**Car Stereo
Service Bulletin**

Model: CDX-A20/A20R

No. 117

Subject: No Operation And Error Message
E-99 On Display

Solution 2-2

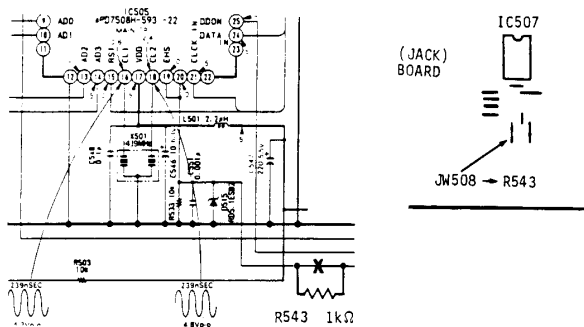
Cause 2

Motor noise affecting the EHS (elevator height sensor) may cause misoperations such as returning the disc to the wrong slot, or taking the disc from the wrong slot.

1. Change C551.
2. Replace JW508 with R543.

Description		Part Number
Former	New	
C551	100pF	1-163-077-00
JW508	Jumper	1-249-417-11
	R543	1k Ω
